Project name: WHITE TAIL RIDGE
Civic Address: 136 FRANK FISHER CR
House model: KINGSWOOD 'R'

LOT 126 SITE/GRADING PLAN
WHITE TAIL RIDGE PH.IV

KINGSWOOD-R-2022

1
9

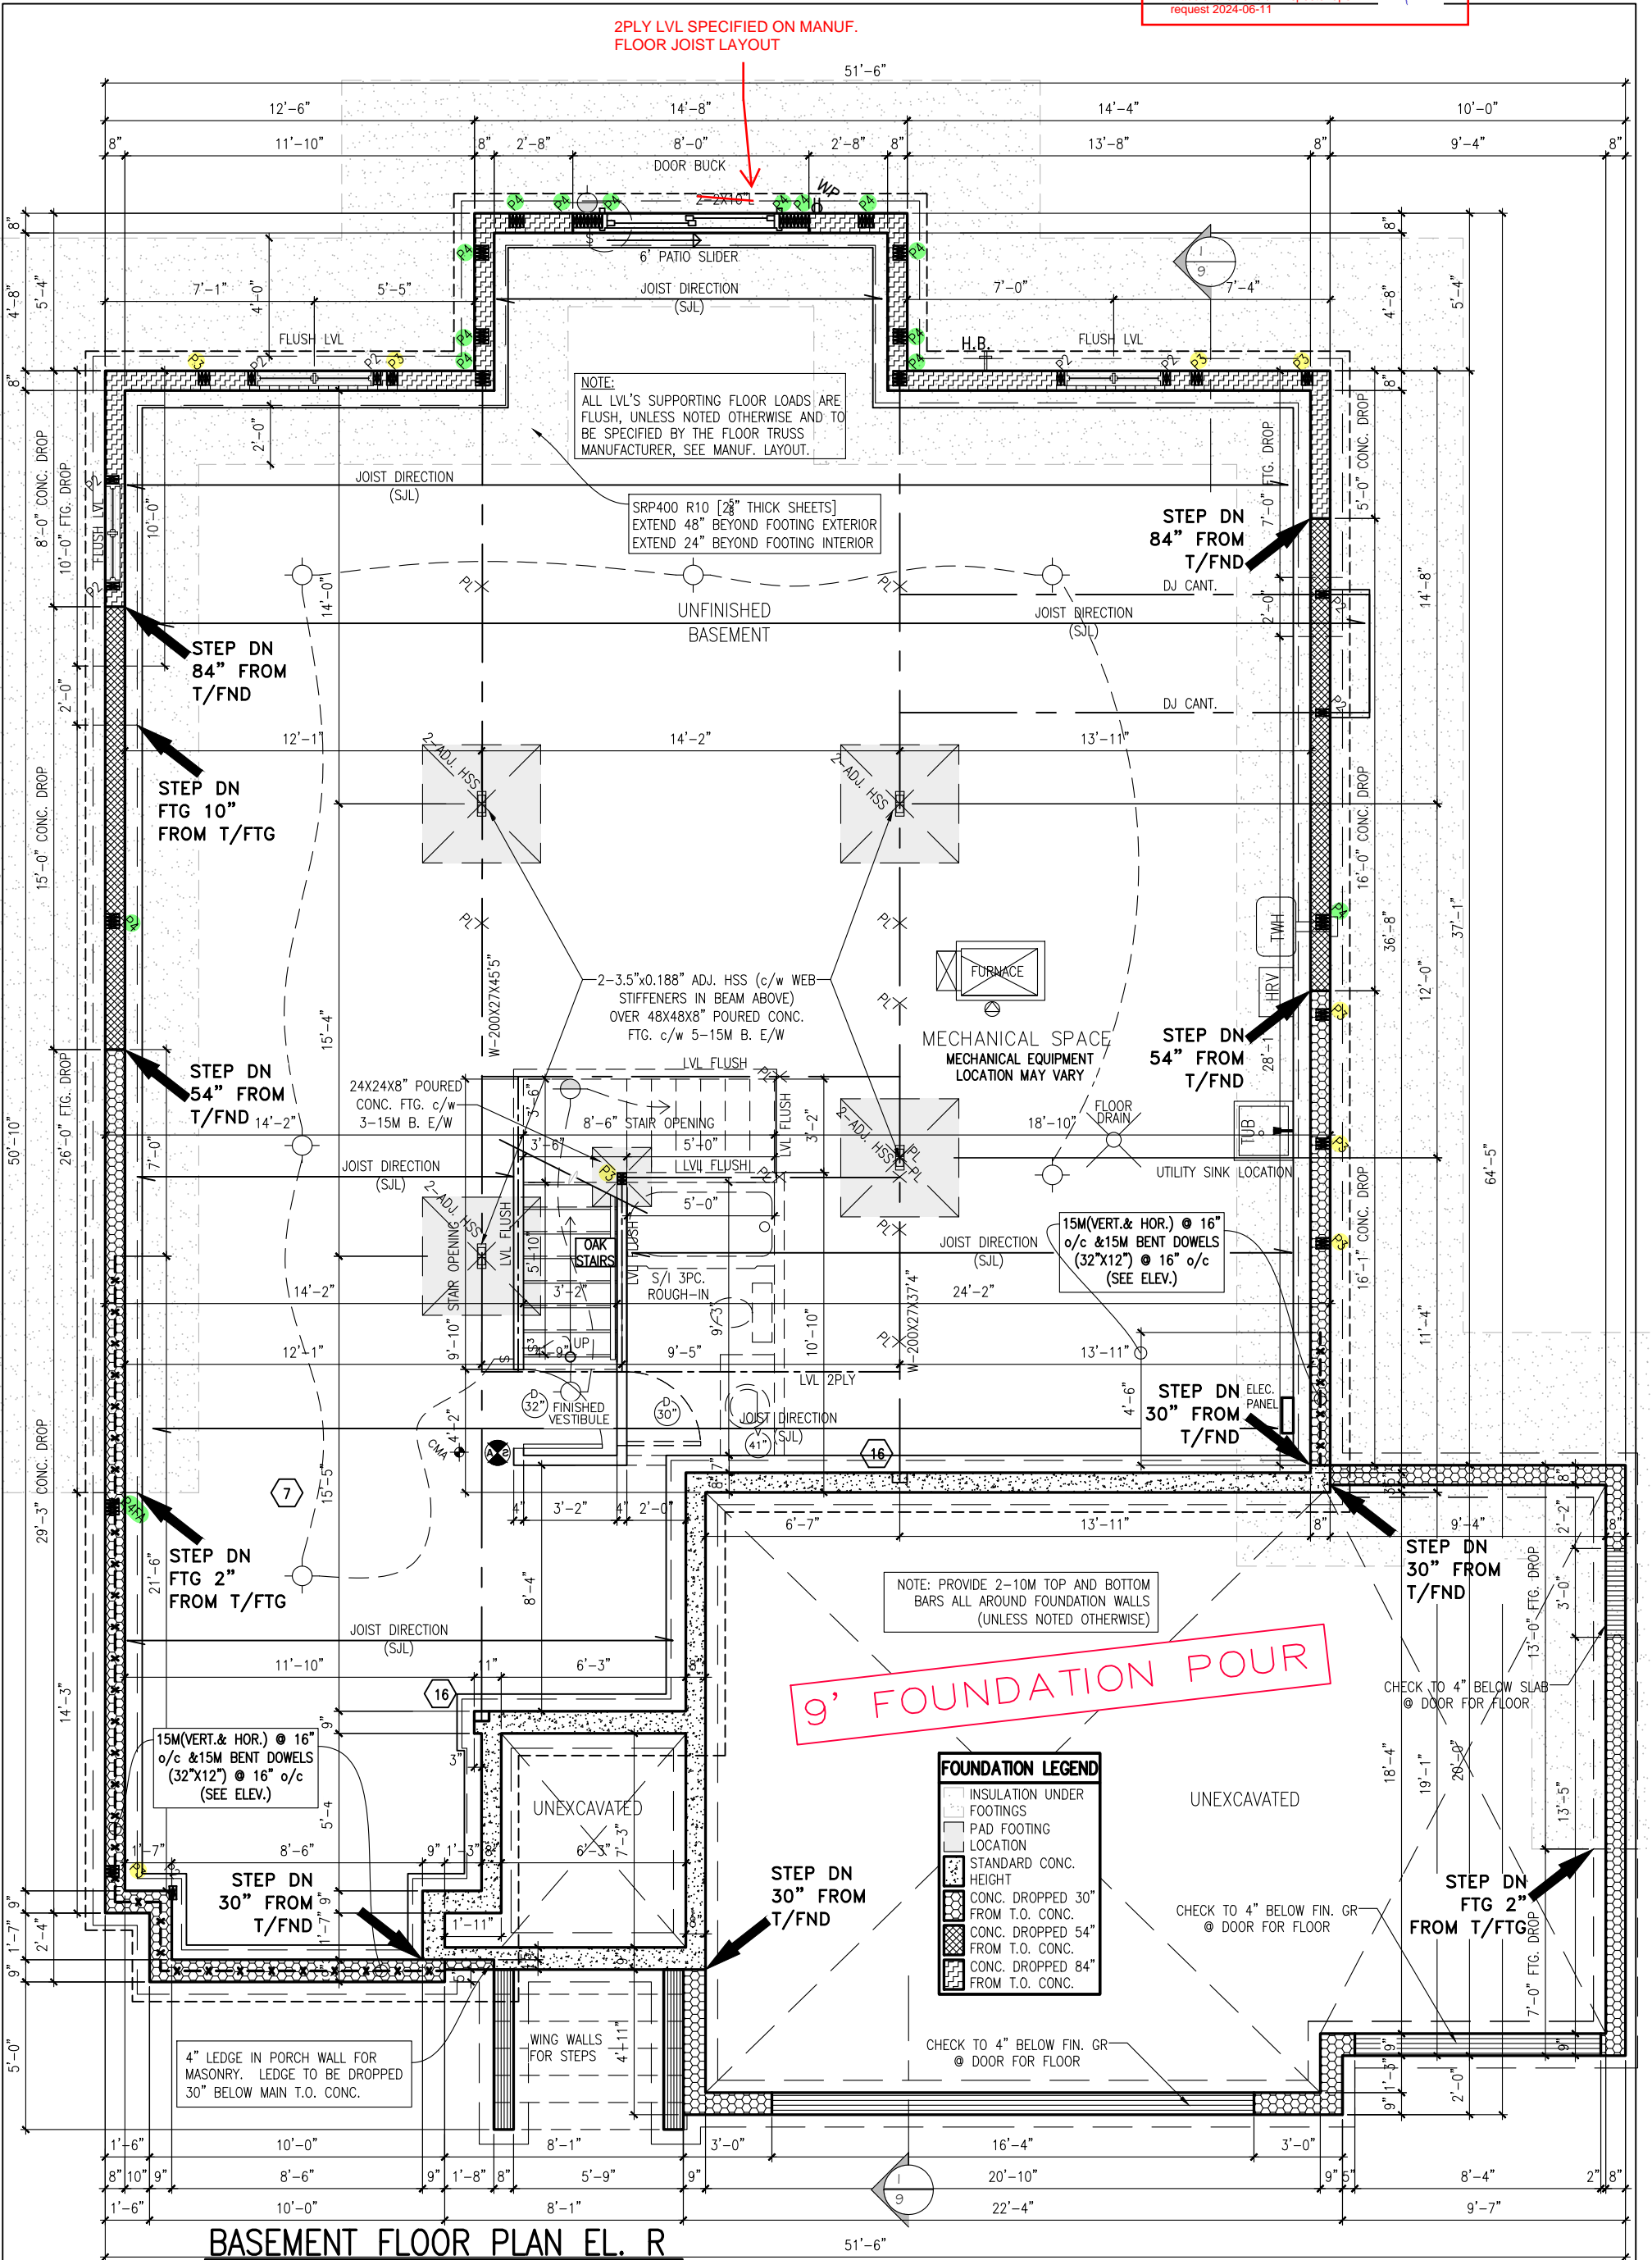
10. It is the opinion of Kollaard Associates that the proposed steel beams and posts shown on Phoenix Homes Sheet # 2R are adequate.
11. The front porch slab reinforcement described on Phoenix Homes Sheet # 1 is adequate.

16. The proposed strip footings, interior pad footings and exterior pad footings shown on Phoenix Homes Page # 2R and noted on Phoenix Homes Sheet # 1 are adequate.

2R9

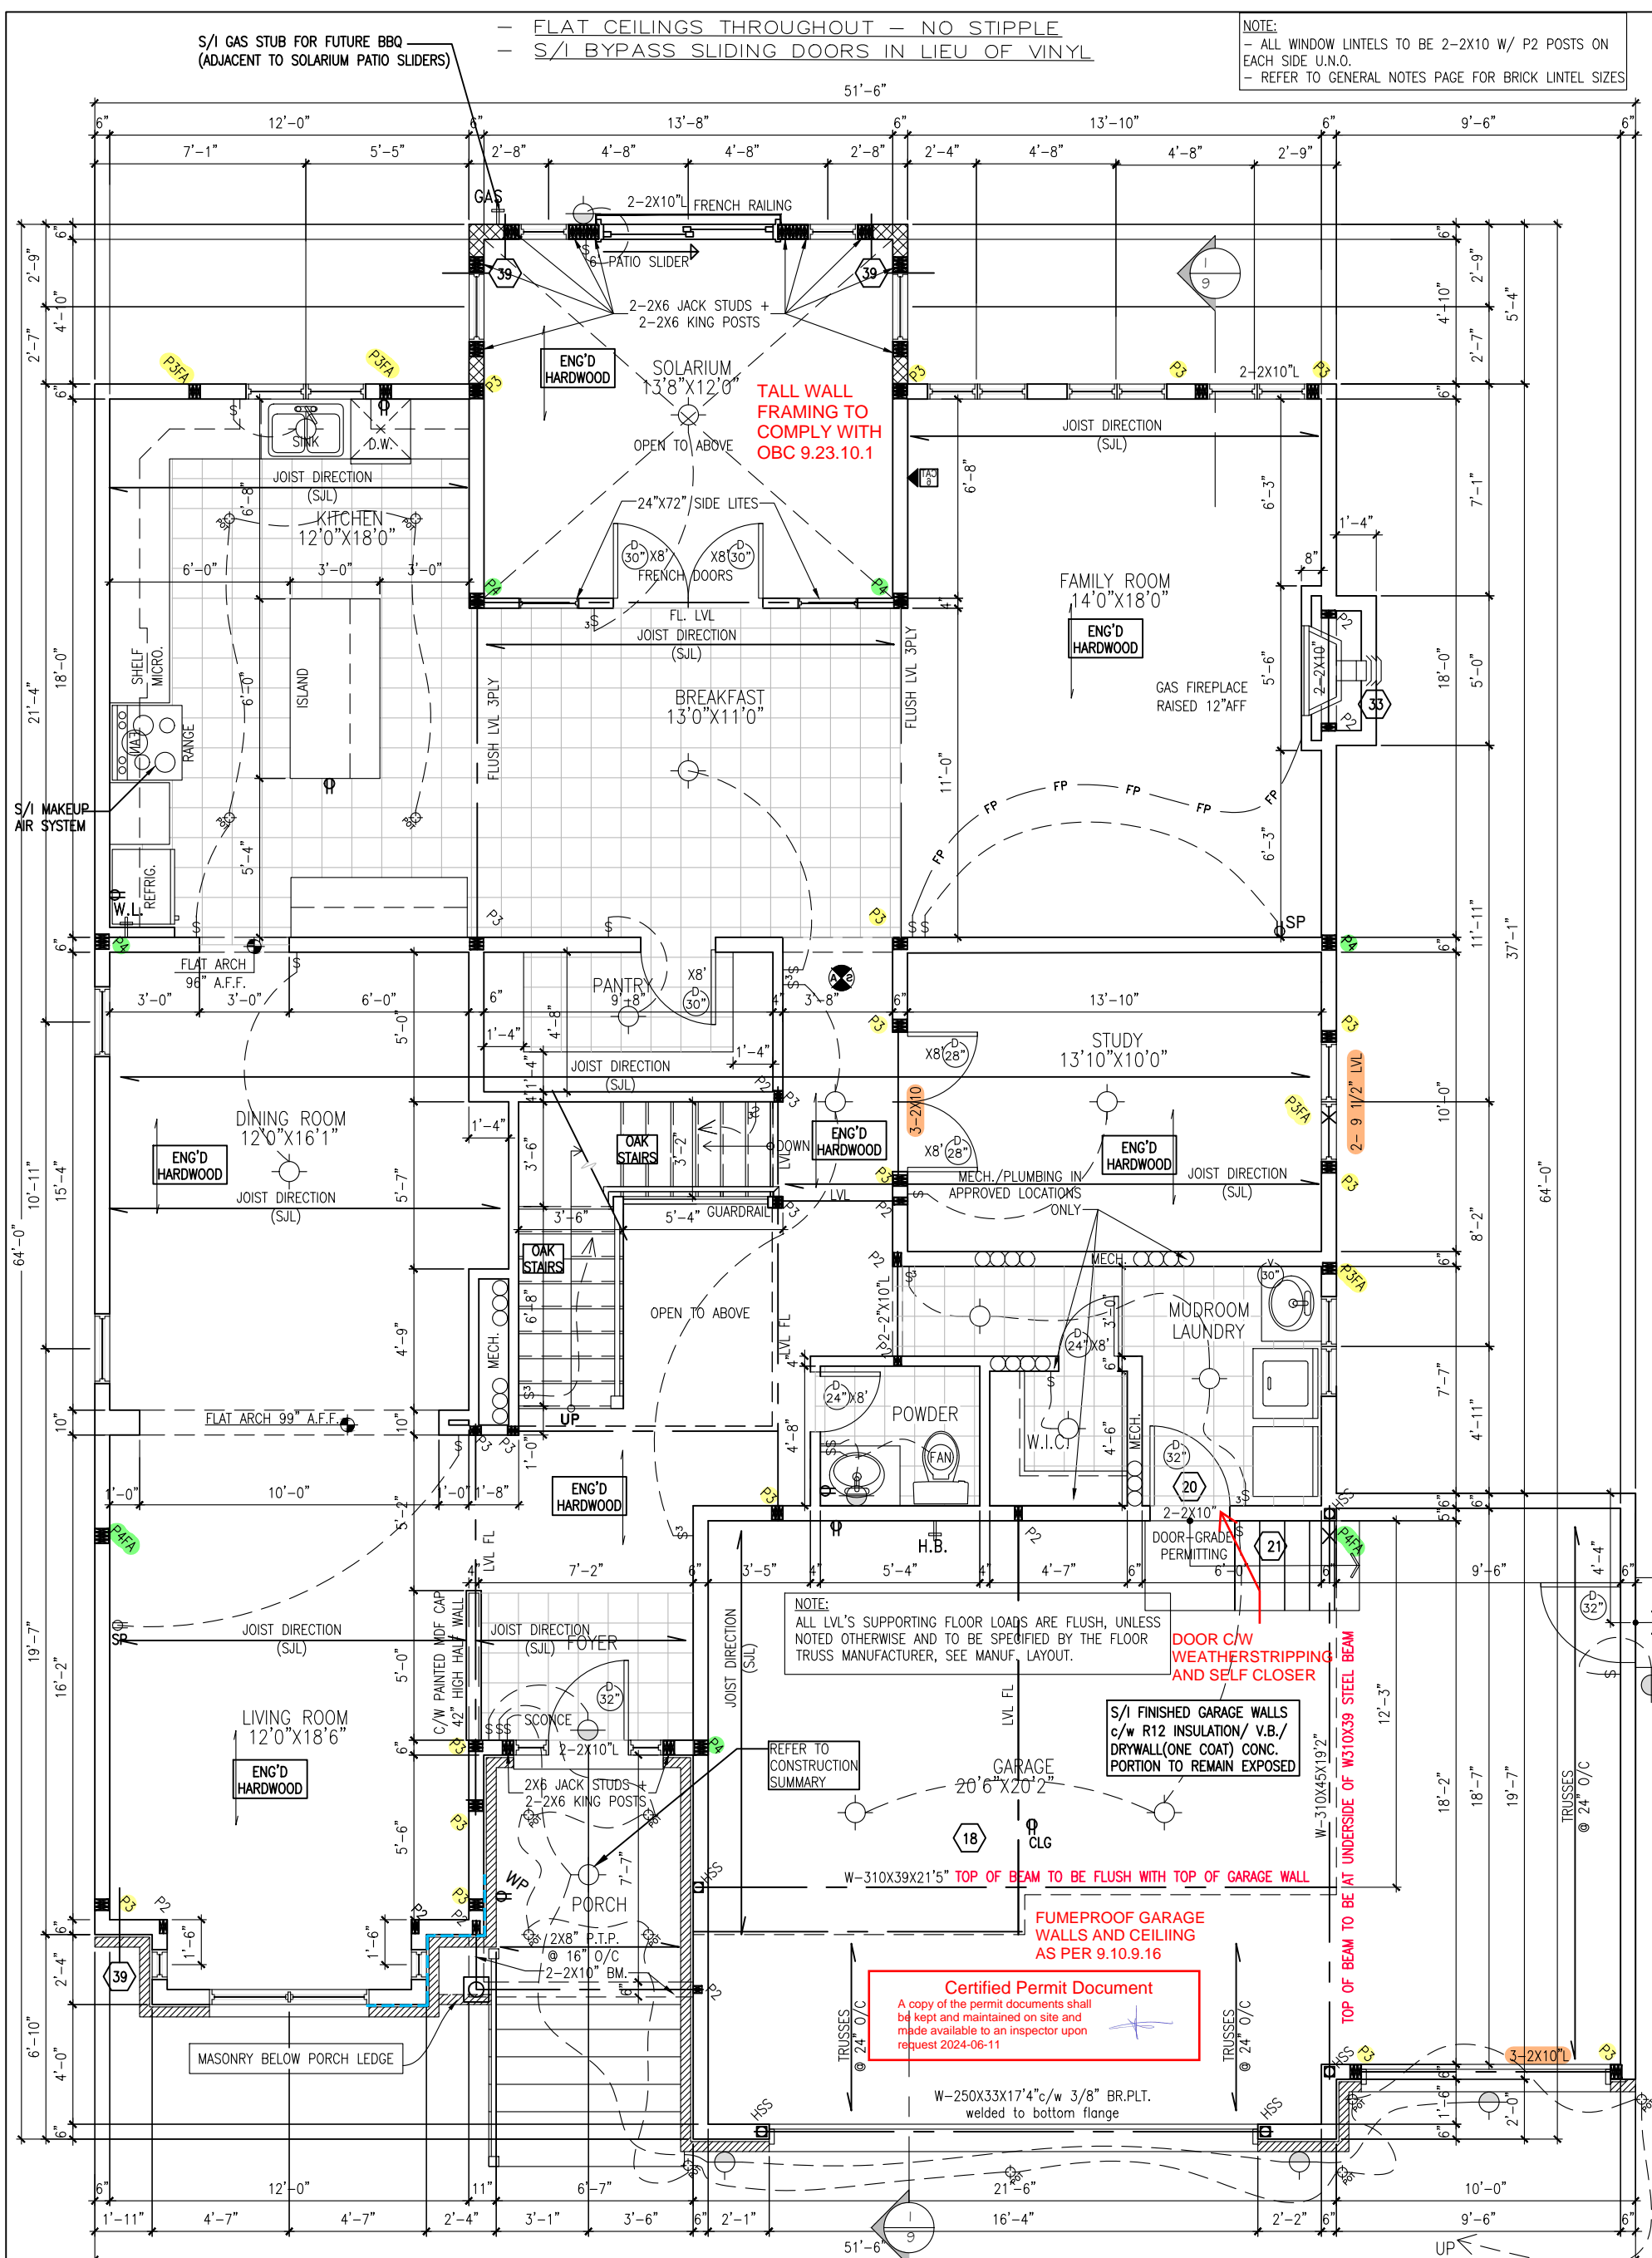
12. As noted on Phoenix Homes Sheet # 2R, the framed walls supporting the intermediate landing may be supported by the basement slab.
13. The proposed 8'-10" foundation walls conform to 2012 OBC Table 9.15.4.2.A. ensuring that the grade difference between the basement slab and the exterior grade (including the garage slab) does not exceed 7'-6½".
